### **REMARKS**

# Changes to Specification and Drawings for Purposes of Clarification

# **TSUDA** et al Serial No. **09/406,684**

Proposed New Fig. 22

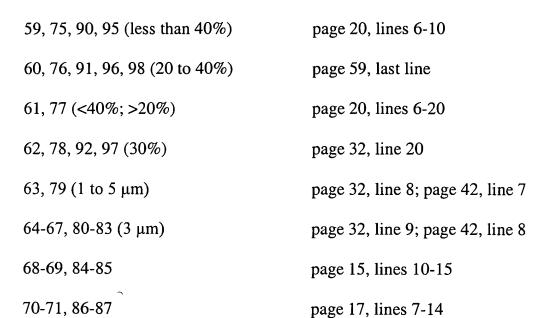
The specification and drawings have been amended to correct typographical errors therein. In particular, the specification as filed stated that Figs. 22-24 illustrated a process according to JP 9-90426 (e.g., see the instant specification as filed at page 3, lines 5-7). A review of JP 9-90426 illustrates that this is not the case. Figs. 22-24 as filed do not illustrate JP 9-90426. Thus, in order to correct the specification as filed, Figs. 22-24 as originally filed have been deleted, and new proposed Fig. 22 is attached hereto. Proposed Fig. 22 attached hereto is the mask used in JP 9-90426, so that the specification is now consistent. Since the specification as filed stated that JP 9-90426 was being

discussed and illustrated, new Fig. 22 taken from JP 9-90426 does not represent new matter.

A method of manufacturing a reflective-type liquid crystal display apparatus described in this patent publication will briefly be described with reference to the drawings. In this regard, Fig. 22 illustrates a mask used in this reference (JP 9-90426).

Fig. 22 is a [cross-sectional view showing the reflective-type liquid crystal display apparatus formed by the conventional manufacturing method;]plan view illustrating a conventional mask used in making a reflective LCD.
